REMARKS

Application No. 10/081,873
Paper Dated October 6, 2003
In Reply to USPTO Correspondence of June 4, 2003
Attorney Docket No. 388-020337

FIG.5

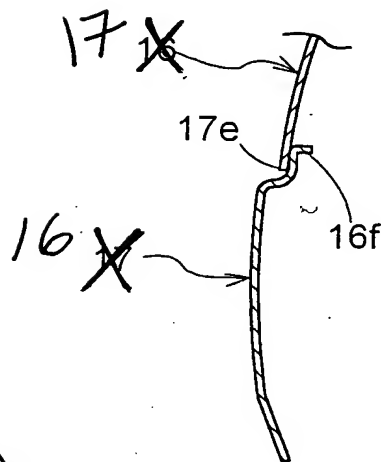
Fig. 5 stands objected to for incorrectly labeling reference numbers 16 and 17. The Applicants believe that the above amendments to Fig. 5 overcome the Examiner's objections. Reconsideration of these objections is respectfully requested.

In amended Figure 5, the locations of reference numerals 16 and 17 have been corrected.

*Change approved
 12-10-03*
